Observations to the current baselines of 2km optical PMDs and proposal to update

Guangcan Mi
Huawei

Introduction

What does the turn point **X** mean:

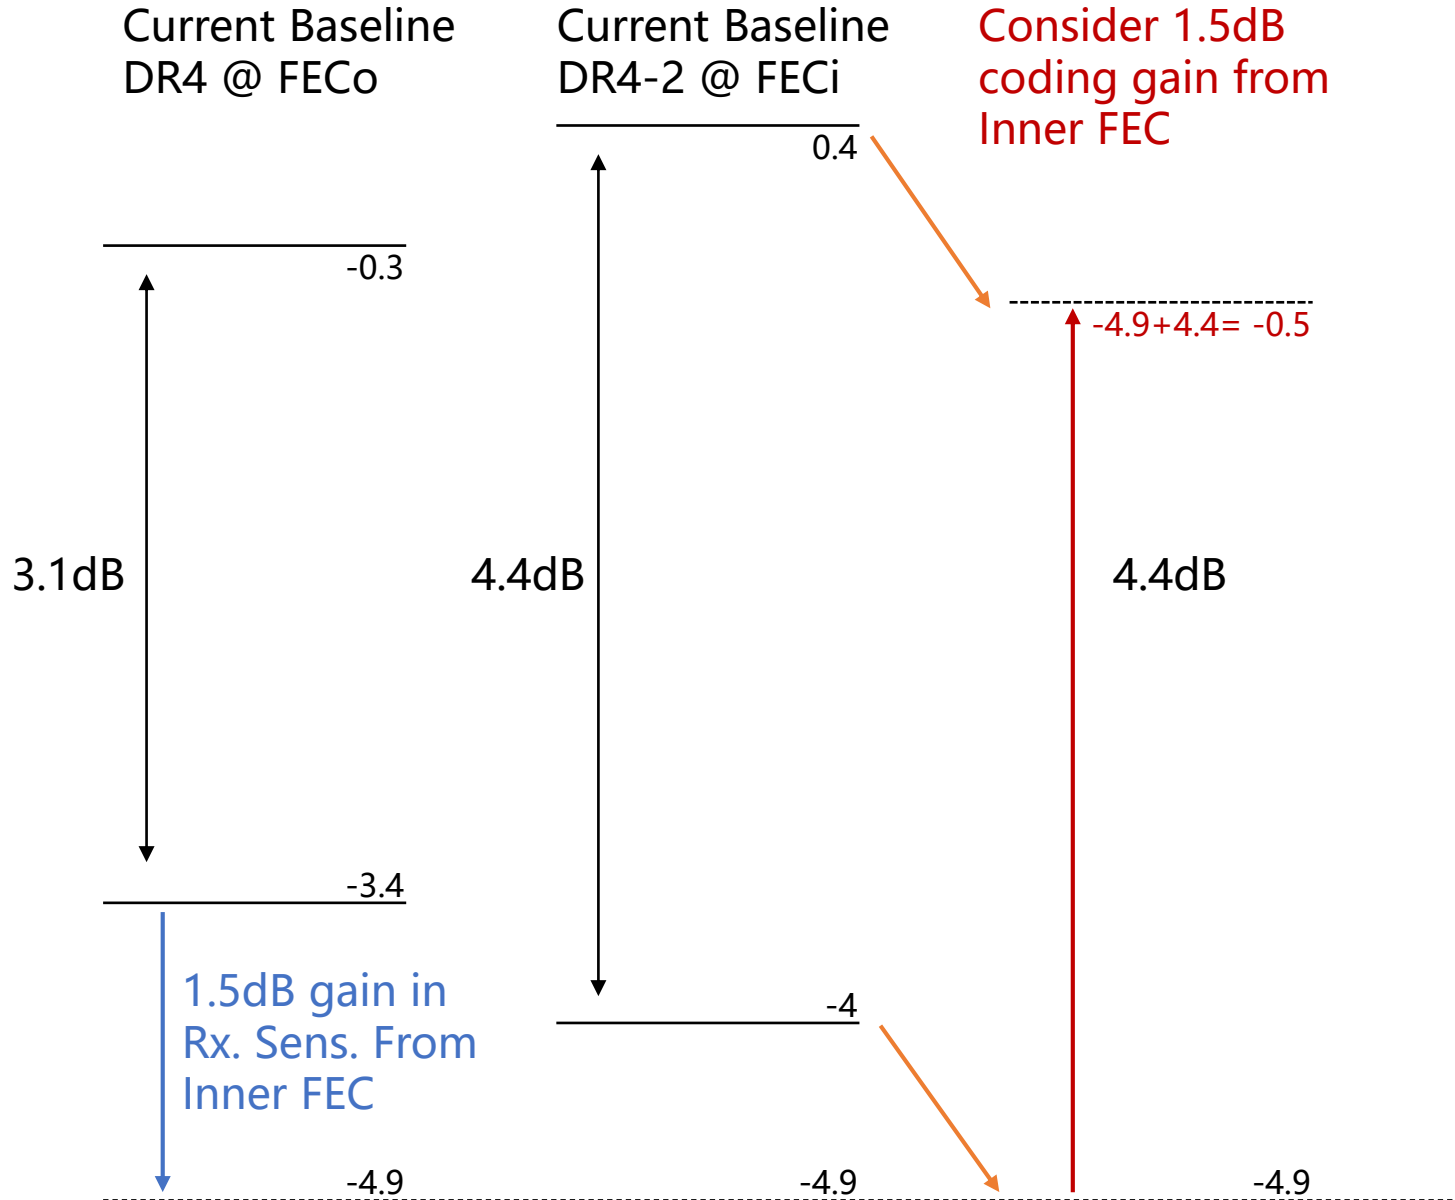
| | Turn point X | |
|-----------|---------------------|--|
| 2km spec | 0.9dB | Suggest to align the specs for 200G/lane FECi specs, may need more data to finalize. |

- For Tx performance degradation up until $TDECQ=X$, the Rx could close the link with the same RS and Tx output power.
- For Tx performance degradation beyond X, performance penalty and CD penalty comes in play, the Rx requires relaxation on RS to close the link, and the Tx output power should increase along.

Why change it:

All the reasons said in topic one.

What about lower the Tx OMA_min of DR4-2

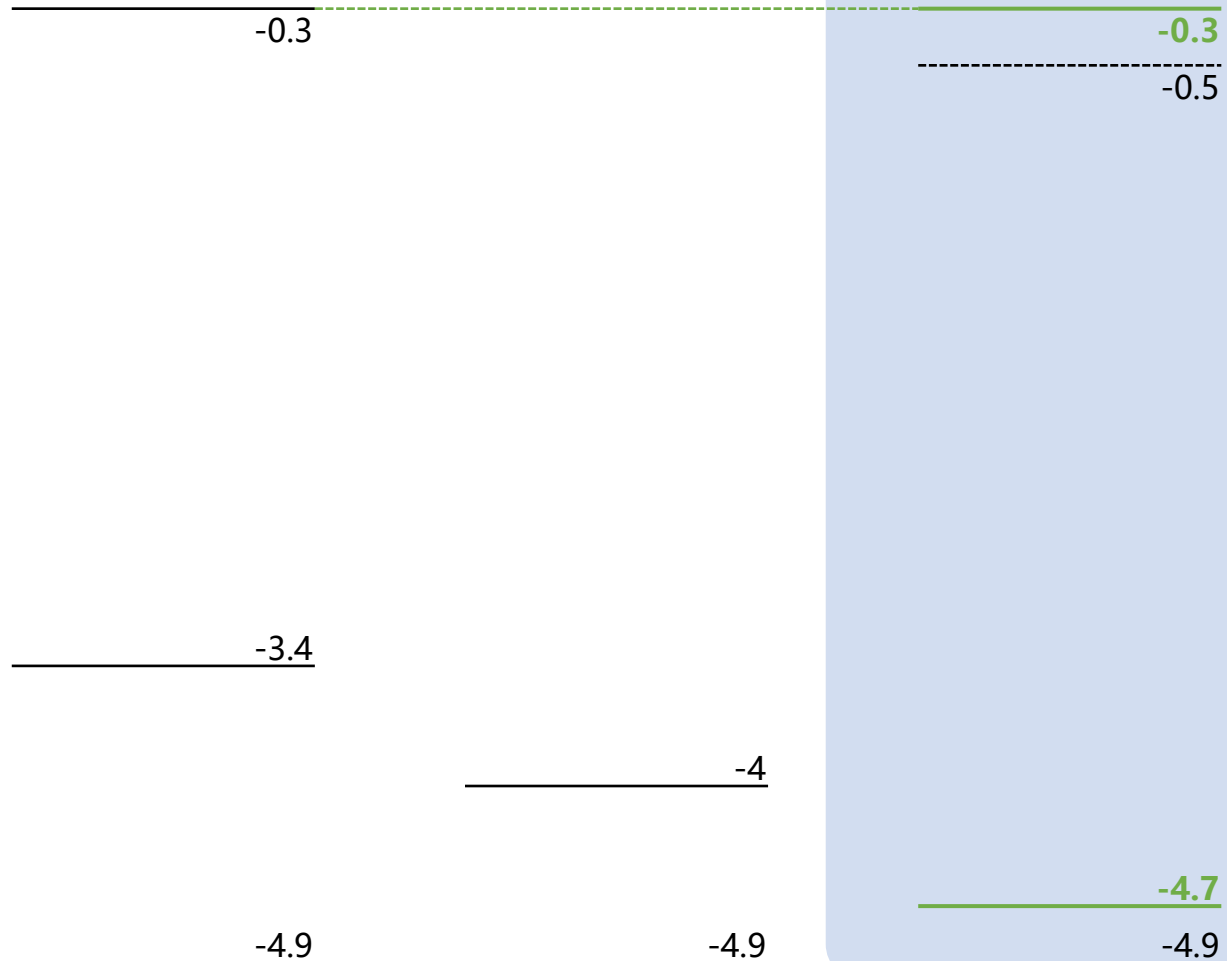
- Take current Rx. Sens. in DR4@FECo specification as anchor point
- In welch_3dj_01b_2311, 1.5dB gain in Rx. Sens. was assumed from using Inner FEC. [Following this assumption](#)
- PSM could have nominal Rx. Sens. of -4.9dB
- The Tx OMA_min for DR4-2 could reach as low as -0.6dB as shown in the left chart.
- The current adopted baseline has Tx OMA_min of 0.3dB.
- **Not exploiting the coding gain of Inner FEC.**
- As commented in mi_3dj_01b_2311, lower Tx OMA spec allows lower power consumption

- ✓ Propose to lower the Tx OMA_{min} and align with that of DR4, **green lines** in the left chart
- ✓ Staying within the coding gain capability of Inner FEC.
- ✓ Requiring -4.7dB of Rx Sens.
 - ✓ Experiment data presented in [rodes_3dj_01a_2311](#) showed promising result of Rx. Sens.
 - ✓ Acquire further data to verify this proposal would be next step.

Proposal to Update
DR4-2 @ FEC_i
